TELEDYNE CONTINENTAL ® AIRCRAFT ENGINE
SERVICE BULLETIN

SB09-5

SUBJECT: Volare Carburetors, LLC SB4 Service Bulletin, Carburetor Bowl to Float Clearance

Bulletin No. SB-4

Floats with Rubbing Wear – FEB 2009
Fig. 1

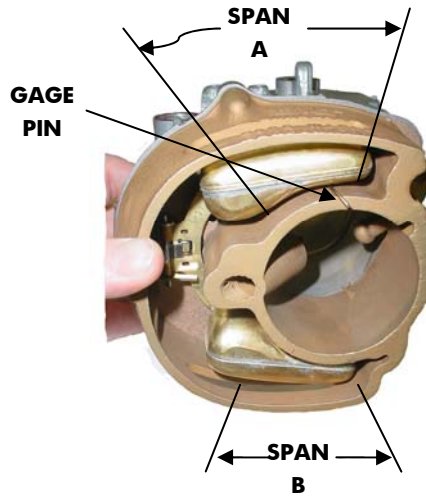
1. **Reasons:** **Warning:** **Failure to follow this advice may result in engine malfunction, damage, injury or death.** Reports of sticking, leaking and/or worn floats have been received, see Figure 1. The specified float/bowl clearance **MUST** exist to ensure proper operation.

4. **Instructions:** This inspection must be conducted each time the bowl is removed. Remove the bowl in accordance with Instruction E-1000 or E-1002 contained in Volare Float Replacement Kit 666-1000 or Kit 666-1002, as appropriate by carburetor model.

Carb Orientation 1, Check Spans A & B
Fig. 2

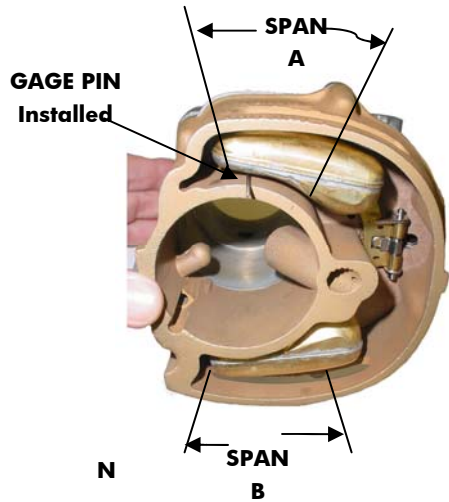
With the clearance tool M-510 or M-513 (dependent on model) in place, orient the carburetor body with one pontoon uppermost, see Figure 2. Check the clearance between the float pontoon and the bowl wall. A .081 inch gage pin (models MA-2, MA-3 & MA-4), or a .051 gage pin (models MA-4-5, MA-4-5AA, MA-5, MA-5AA, MA-6 and MA-6AA) must pass between the lower surface of the upper pontoon and the throttle bore wall and between the lower surface of the lower pontoon and the lower bowl wall without touching either pontoon. Reorient the carburetor so that the other pontoon is uppermost, see Figure 3. Repeat the clearance check. If, as the gage pin is moved along between the float and the bowl wall the gage pin contacts either pontoon, float clearance is inadequate and the float assembly must be replaced.

Install new parts as necessary. Torque and safety the cover screws and test the carburetor in accordance with instructions contained in the appropriate Carburetor Service Manual (MSAFSM) and Instructions E-1000 and E1002, appropriate to the model. Note: Instructions E-1000 and E1002 apply only to the installation of solid blue epoxy floats. **The float clearance requirements in this Service Bulletin apply to all Volare carburetors to which this bulletin is applicable, i.e., carburetors equipped with brass floats, regardless of the manufacturer of the float and MUST be adhered to.** *This Service Bulletin is not applicable to carburetors equipped with solid, blue epoxy floats, Volare part numbers 30-862 and 30-864.*
